Technical Service Information

THM 4L60-E

NEW DESIGN OUTPUT SHAFT SPEED SENSOR

Figure 1.

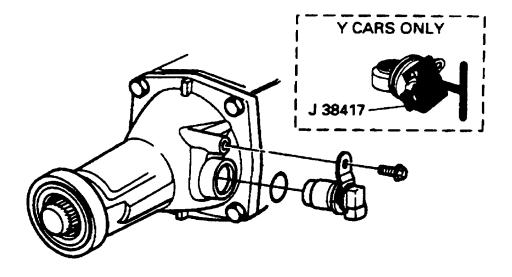
Beginning at the start of production for 1996 models, some THM 4L60-E transmissions were built with a new design Output Shaft Speed Sensor, as shown in Figure 1. Corvette models will be the only vehicle that will continue to use the previous design speed sensor, as shown in

(1) EXTENSION HOUSING - New casting with smaller speed sensor bore diameter, to accept the new design Output Shaft Speed Sensor, as shown in Figure 1.
